UNITED STATES PATENT AND TRADEMARK OFFICE

APPLICATION NO.	FILING DATE	FIRST NAMED INVENTOR	ATTORNEY DOCKET NO.	CONFIRMATION NO.
09/720,657	12/28/2000	Petra Koschany	MSI	4076

Office Action Summary

DETAILED ACTION

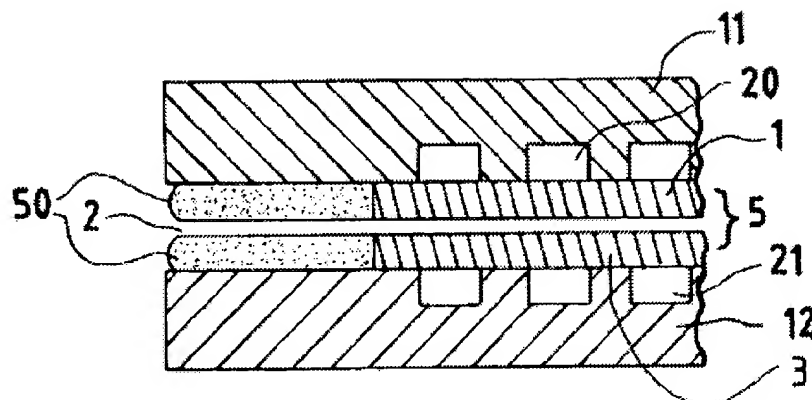
With respect to Claim 1, Schmid et al. specifically disclose a membrane electrode assembly that comprises a polymer electrolyte membrane(column 4, line 63 – column 4, line 17 of this reference; see also Figure 3a, shown below), grooves for gas distribution(column 7, lines 14-17), bipolar separator plates resting against the gas distribution grooves(column 4, lines 32-40; see also column 7, lines 14-17) wherein the outer periphery of the membrane electrode assembly is filled with an adhesive to form a liquid- and gas-tight seal(column 6, lines 55-58). The Examiner would like to point out that the gas distribution grooves are interpreted as gas diffusion layers and the area where the adhesive is applied to is interpreted as a circumferential volume zone.

With respect to Claim 8, Schmid et al. disclose a membrane electrode assembly that comprises a polymer electrolyte membrane (column 4, line 63 – column 4, line 17 of this reference; see also Figure 3a, shown below), grooves for gas distribution (column 7, lines 14-17), bipolar separator plates resting against the gas distribution grooves (column 4, lines 32-40; see also column 7, lines 14-17) wherein the outer periphery of the membrane electrode assembly is filled with an adhesive to form a liquid- and gas-tight seal (column 6, lines 55-58). With respect to Claim 11, Schmid et al. disclose using an epoxy resin as an adhesive (column 5, lines 35-46). With respect to Claim 12, Schmid et al. disclose impregnating a membrane electrode assembly with the adhesive and waiting
